**S12A AMENDMENT OF PLAN APPLICATION  
APPROVED NGAU TAM MEI  
OUTLINE ZONING PLAN NO. S/YL-NTM/12**

**PROPOSED REZONING FROM “R(C)” TO “G/IC”  
FOR A PROPOSED “SOCIAL WELFARE FACILITIES”  
(RESIDENTIAL CARE HOMES FOR THE ELDERLY)  
(RCHE)**

**AT LOT 4823 IN D.D.104, 81 SAN TAM ROAD,  
SAN TIN, N.T.**

**FURTHER INFORMATION  
JAN 2023**

Figure 2

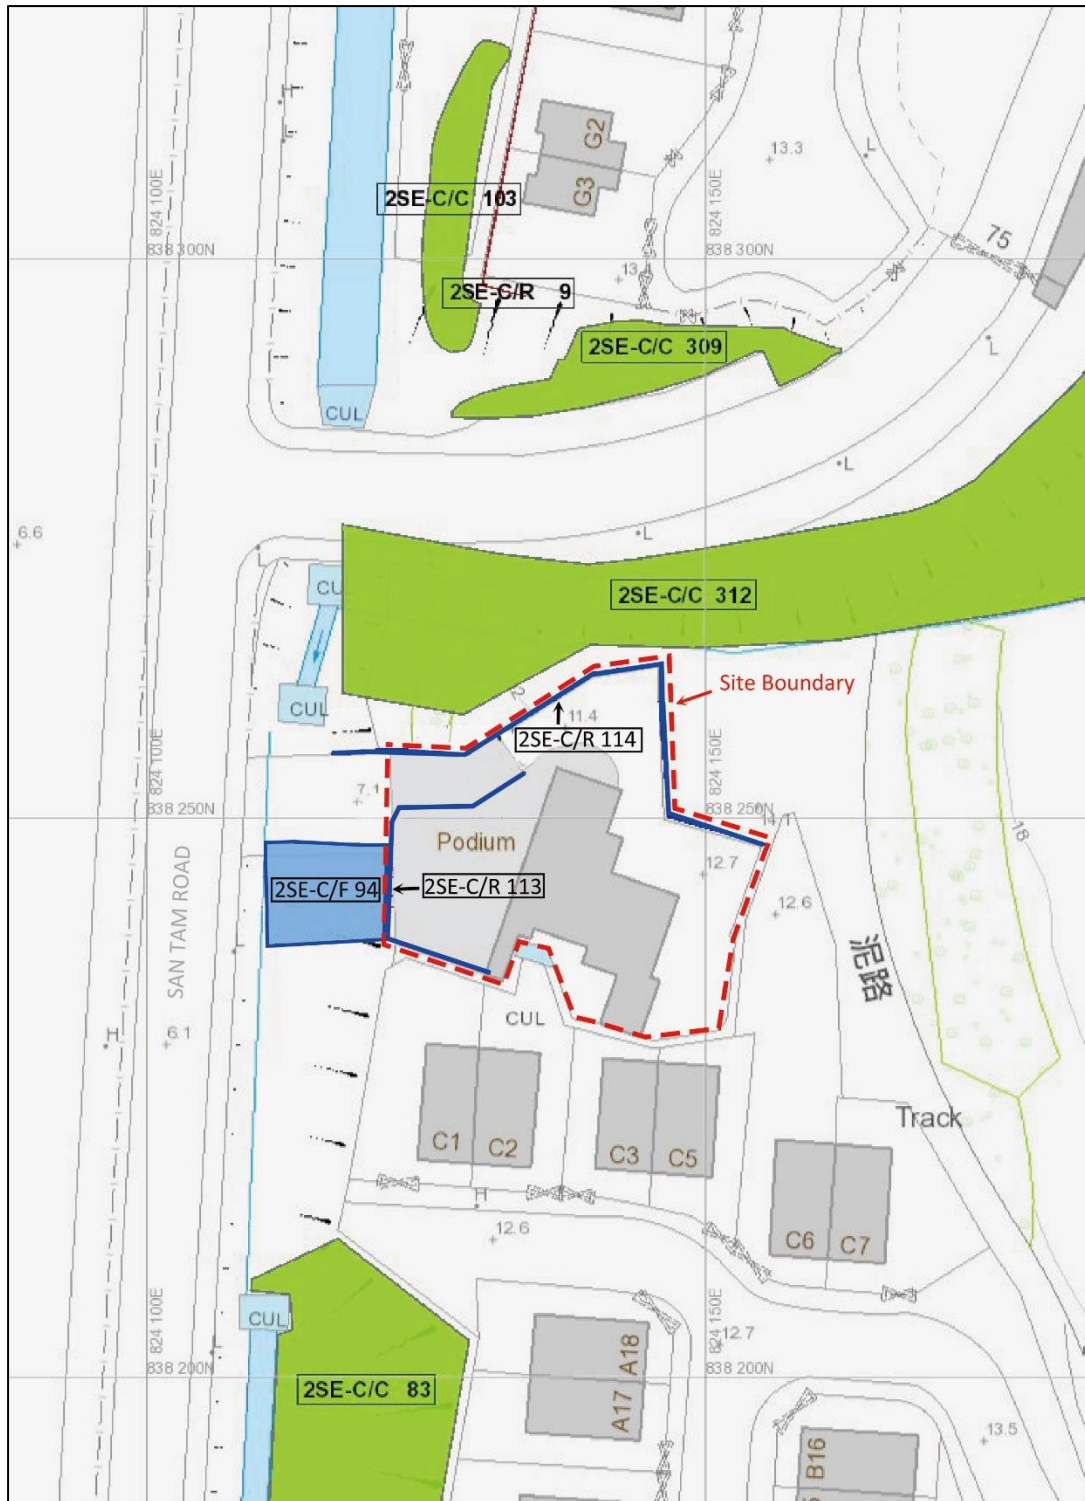
Comments	Response
<p>2. Comments of the Head of Geotechnical Engineering Office, Civil Engineering and Development Department (H(GEO), CEDD) as follow:</p> <p>2. Section 4. As shown in Figure 2, it is noted that there are four registered man-made slopes (i.e. Features No. 2SE-C/C312, 2SE-C/F94, 2SE-C/R113 and 2SE-C/R114) within and adjacent to the application site. The applicant should provide cross-sections with the proposed construction works (including excavation &amp; lateral support, foundation and site formation, if any) across the application site showing the aforementioned registered man-made geotechnical features.</p> <p>3. Section 3, 7 and 8(1). As mentioned in the GPRR, the existing 3-storey house with a car ramp will be demolished and re-developed into a 10-storey building with an approximate height of 29.6 m, together with the access point at ground level of the building lowered from +12 mPD to +7.33 mPD. In view of the proposed building and site formation works would be carried out immediately adjacent to man-made geotechnical features no. 2SE-C/C312 and 2SE-C/F94, please request the applicant to double check on the validity of the slope (2SE-C/F94) would be undisturbed” (section7) and, “...existing gentle slope (2SE-C/F94) in front would remain unchanged.” (Section 8). The applicant should clearly state whether any necessary slope upgrading works and slope stability assessment of the concerned slope should be carried out prior to commencement of works.</p>	<p>The replacement and additional pages for Geotechnical Planning Review Report attached has included four registered man-made features (2SE-C/C312, 2SE-C/F94, 2SE-C/R113 and 2SE-C/R114). Cross-sections across the application site has also been included.</p> <p>The replacement and additional pages for Geotechnical Planning Review Report attached has included the necessary slope upgrading works and slope stability assessment of the concerned slope 2SE-C/C 312 and 2SE-C/F94.</p>

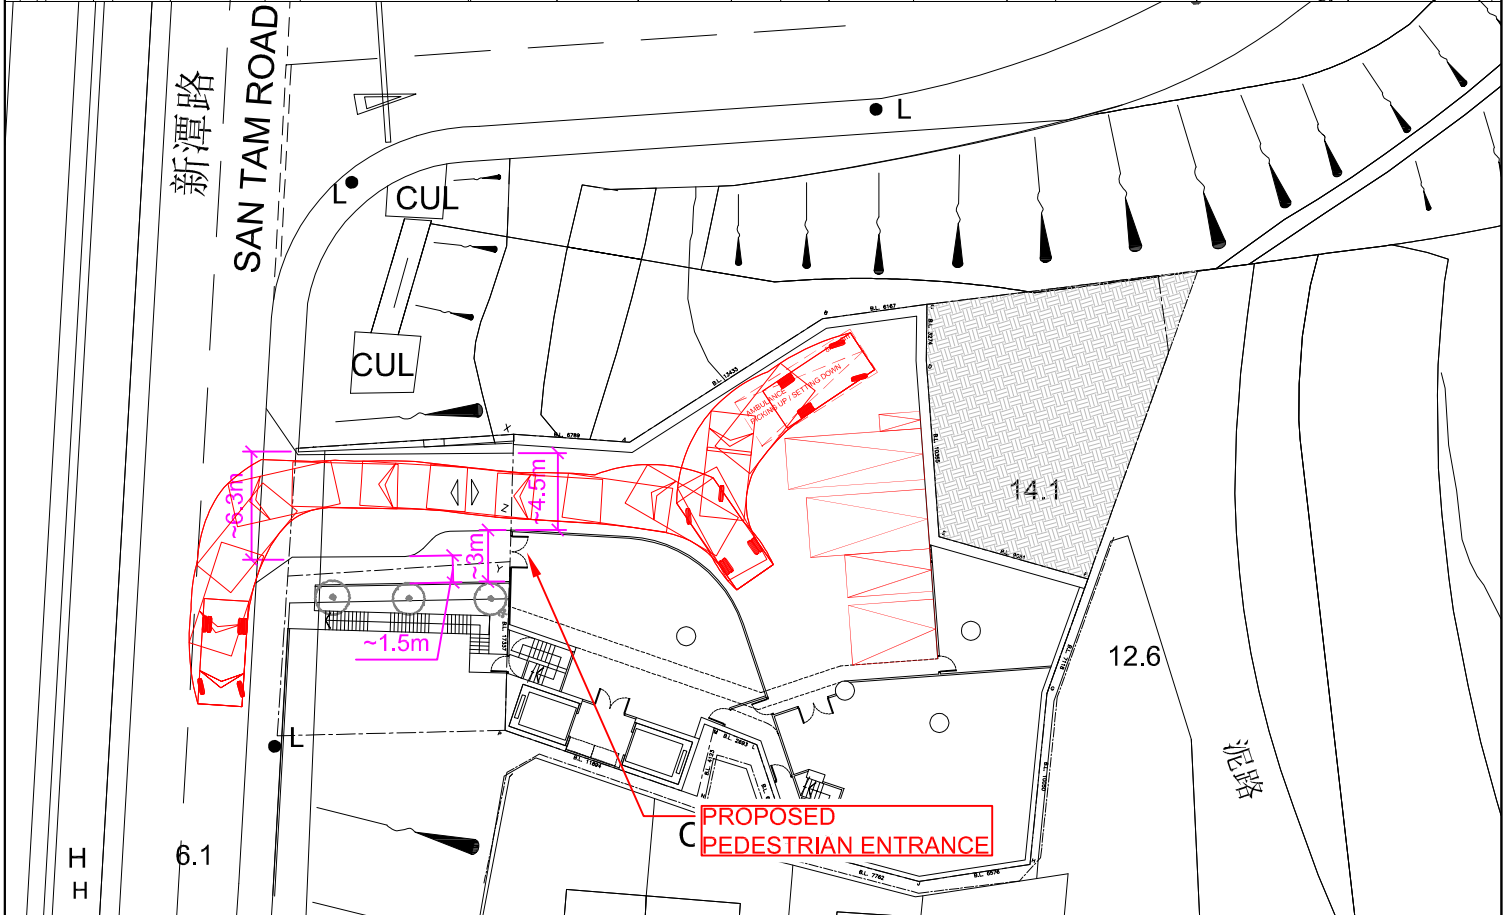
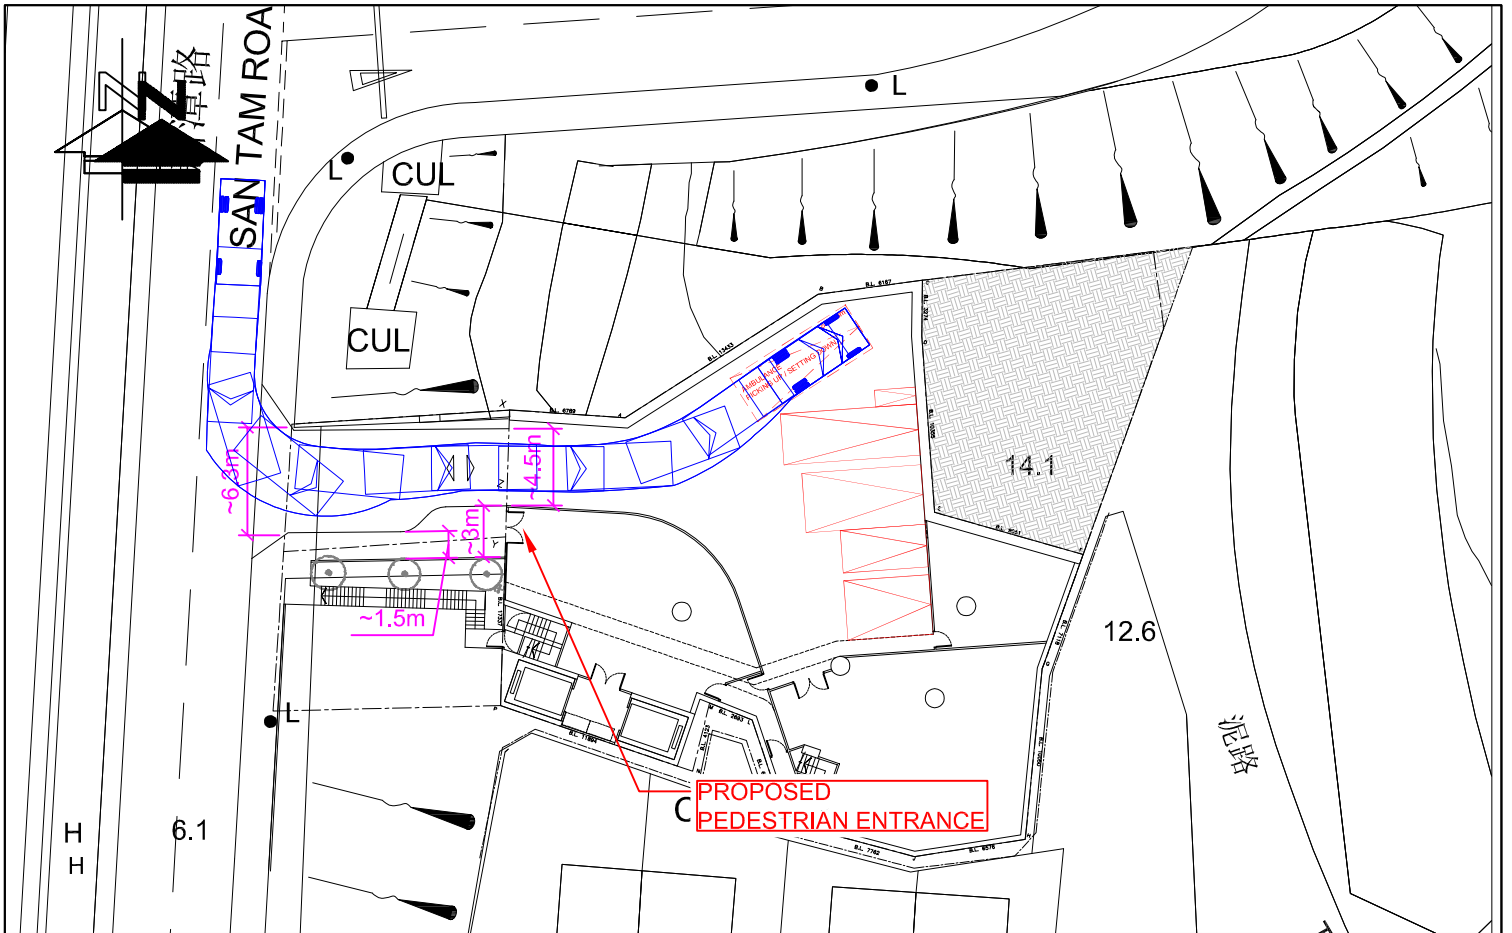
e) Table 2.3 – <ul style="list-style-type: none"><li>• Please specify the headroom of the of the types of vehicle in the table</li><li>• Please include the picking up and setting down point for ambulance</li></ul>	Please find the revised Table 2.3 with information of headroom of the types of vehicle in the table for your information.  Please refer to <b>Figure 2.1 (Rev.A)</b> for the proposed picking-up/setting down point for ambulance, and <b>Figure SP-03</b> showing the swept path of ambulance ingressing and egressing the site.

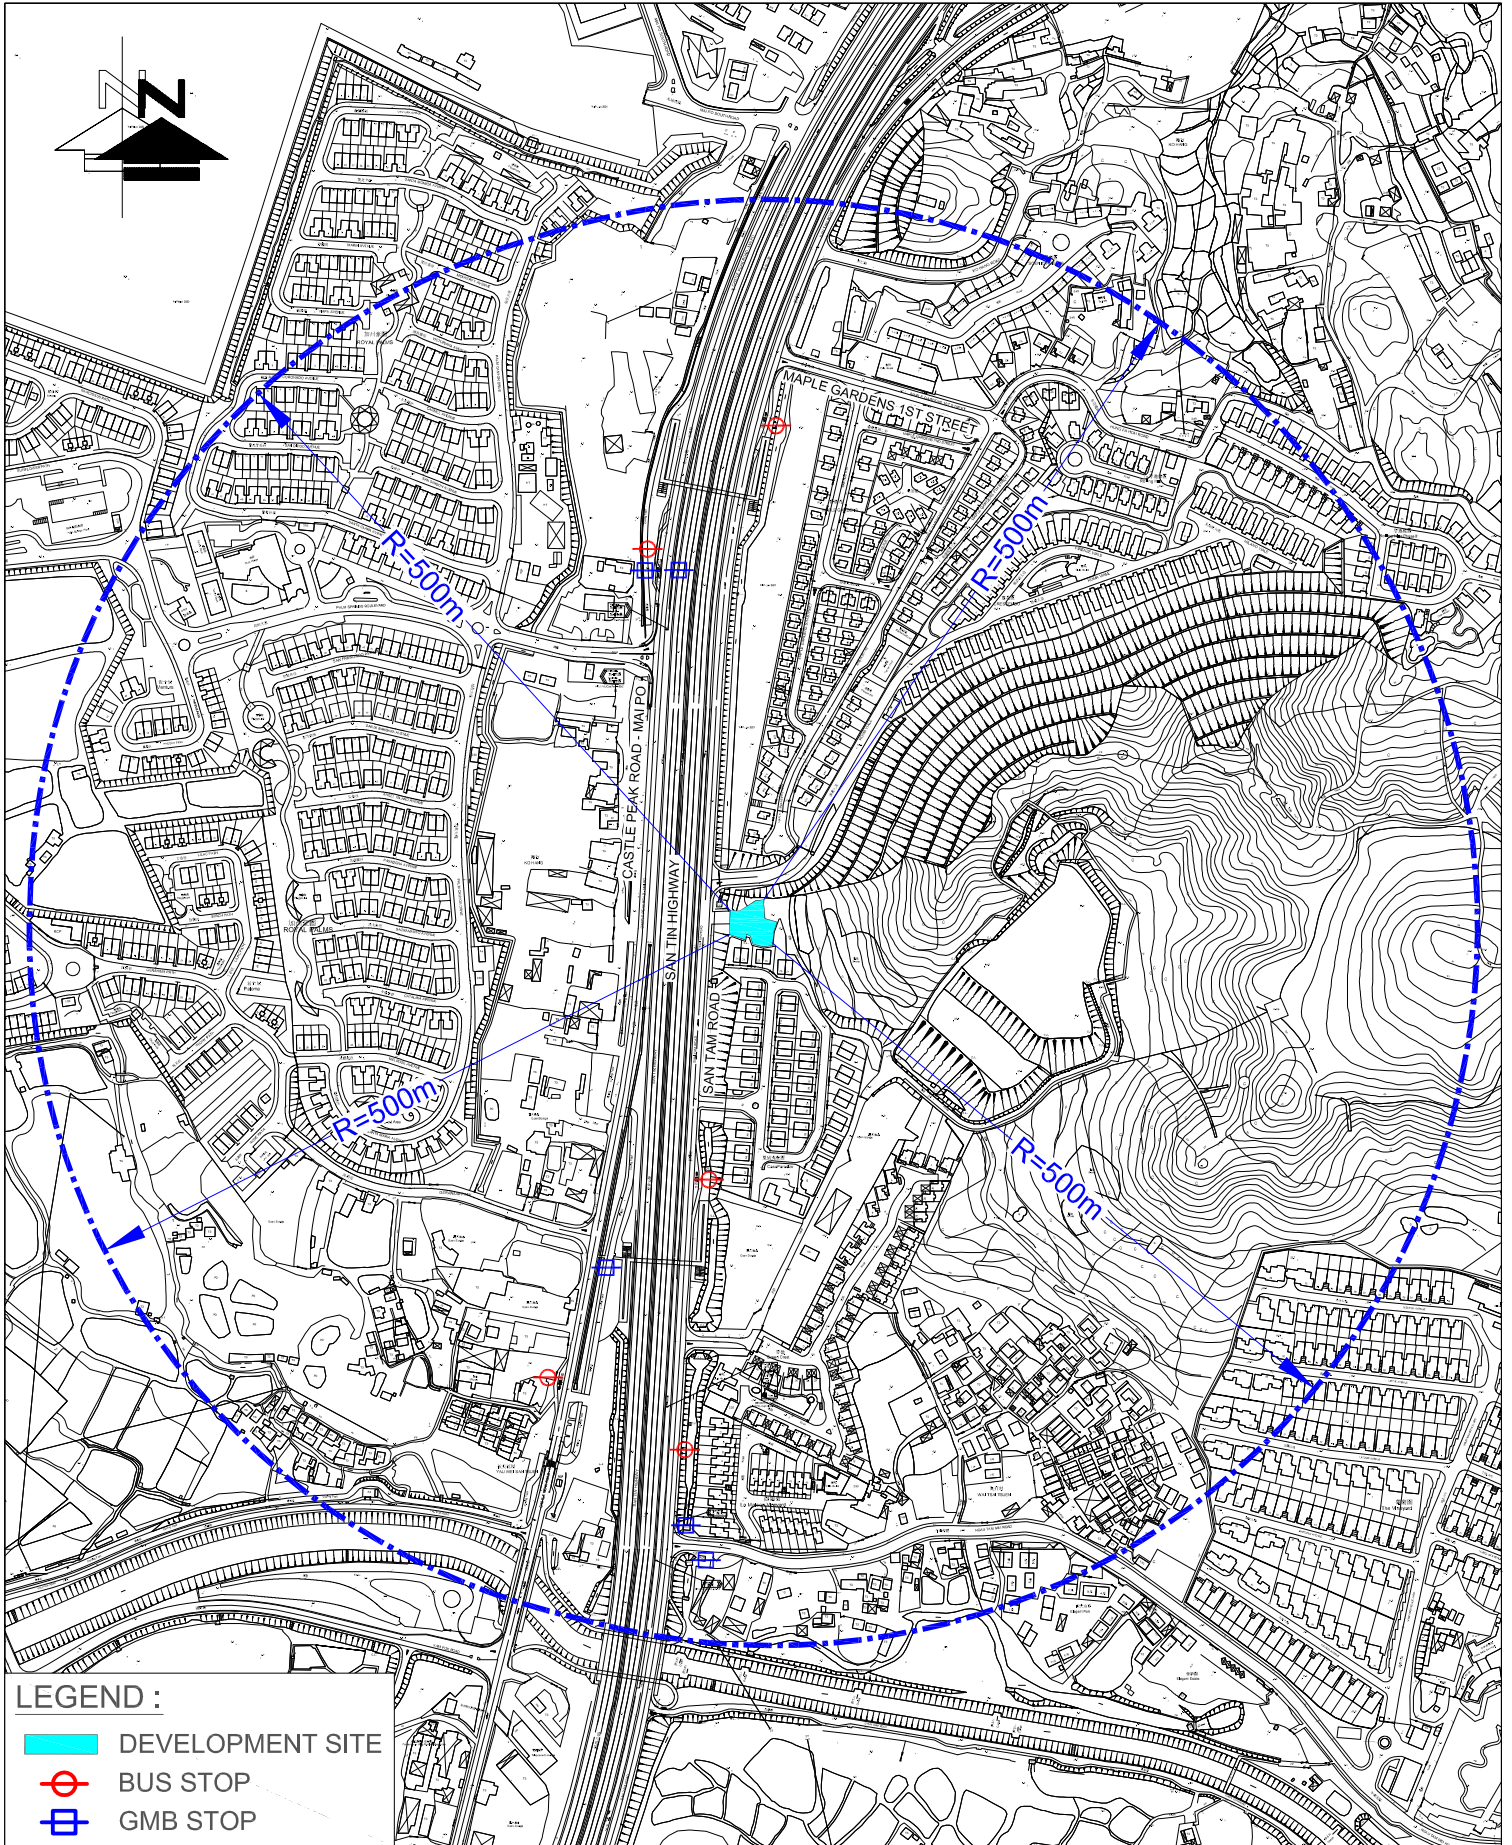
h) Figure 2.1 – Please specify the clear width of proposed ingress/ egress, driveway and footpath.	Please find the <b>Figure 2.1 (Rev.A)</b> with marked width of proposed ingress/ egress, driveway and footpath for your information.
